MAS003339 MSC 22-46

Service Campaign 542: MC20 Door Rattle Noise

DATE: November 17, 2022

Figure 3

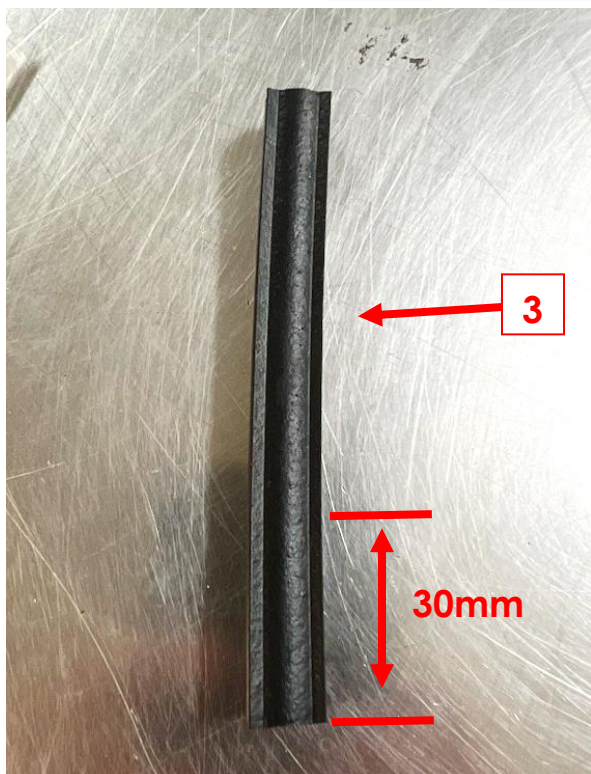
1. Always check in ModisCS+ to see if the vehicle is involved in this campaign and if the campaign has not been previously performed.
2. Open the left door and, position yourself in the area at the door hinge, separate the gasket (1) from the gasket (2) which are the two sections that overlap each other. (See **Figure 1** and **Figure 2**)

3. Insert the gasket reinforcement filler (3) into gasket (1) as shown in **Figure 4**, allowing 30 mm of the filler to extend into gasket (2). (See **Figure 5** and **Figure 6**)

- 4 After inserting the reinforcement filler, reassemble gaskets (1) and (2) back together, make sure the filler is positioned 30mm into gasket (2) and perform a functional test to verify the correct rework.
- 5 Perform the rework procedure also on the other door
- 6 After completing both doors, the procedure is complete.
